## 8A Miscellaneous Electrical Systems

The information in this appendix of the reference ABWR DCD, including all Subsections and figures, is incorporated by reference with the following departures and supplements.

**Figure 8A-1 Site Plan (Grounding)**

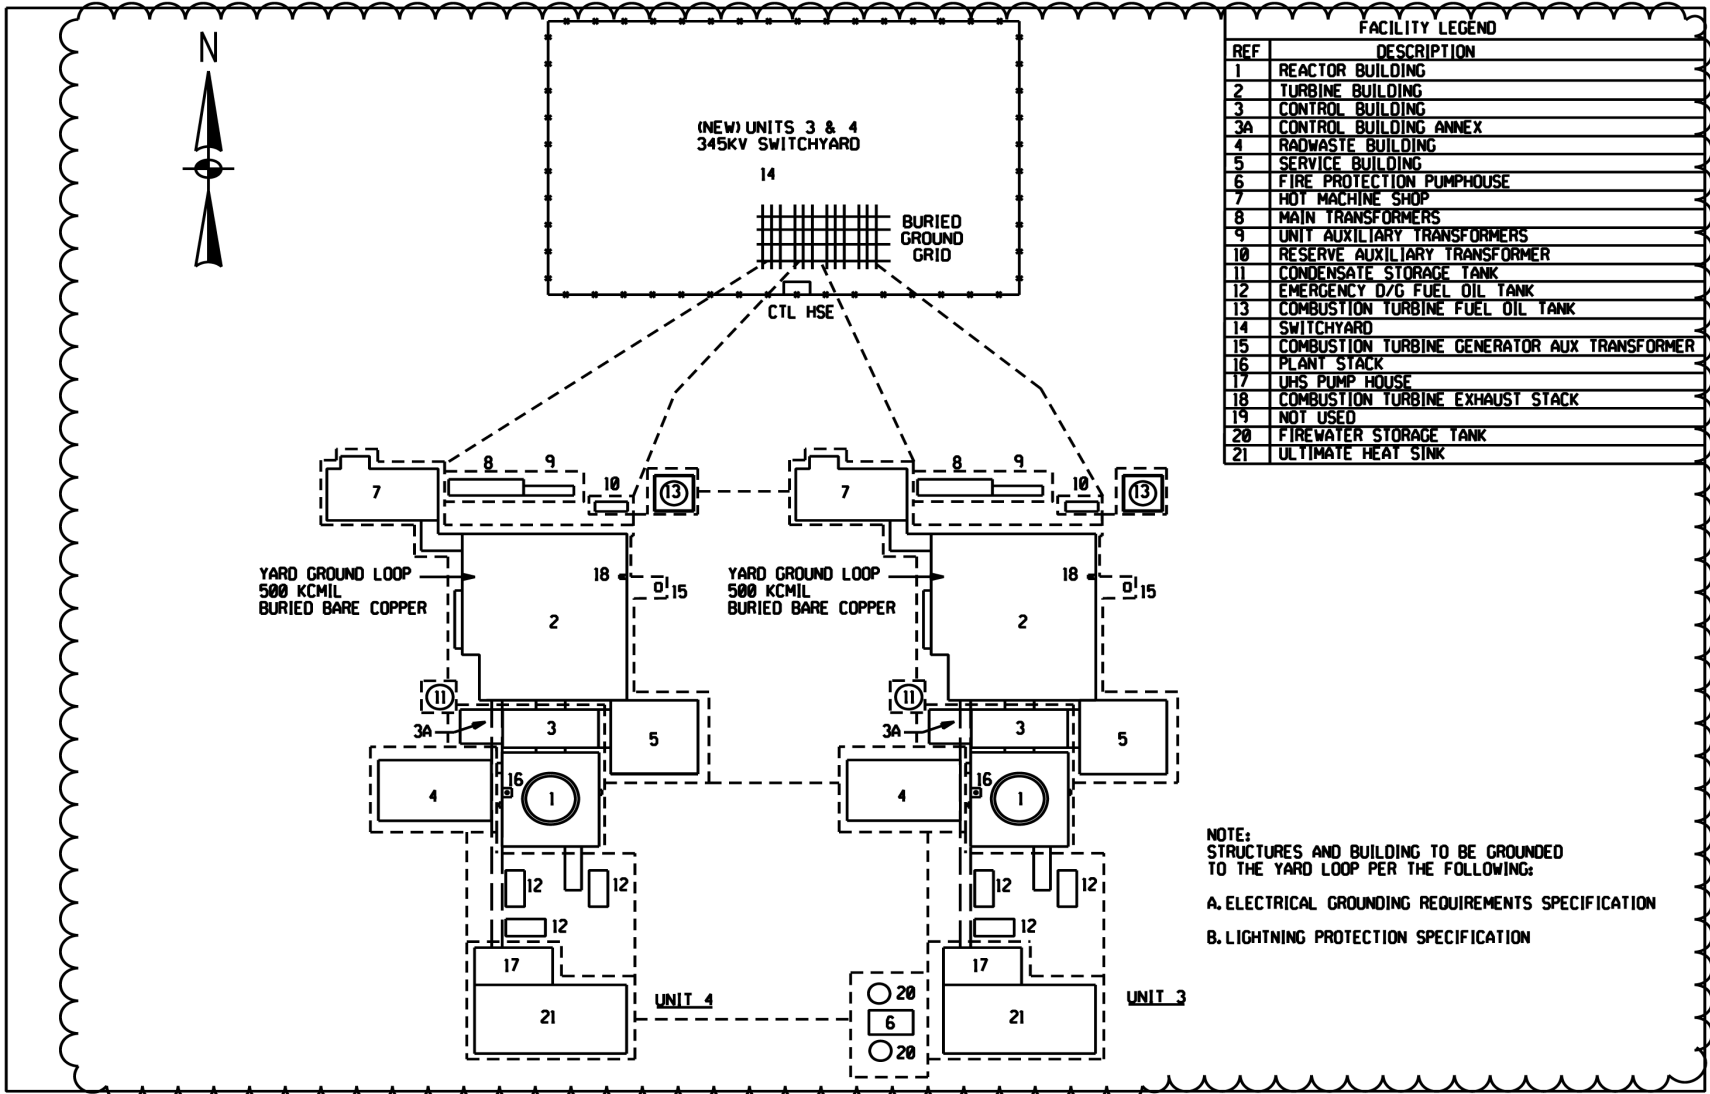
STP DEP 1.1-2 (Figure 8A-1)

STP DEP 1.1-2

- (3) *A plant grounding grid shared between STP Units 3 & 4*
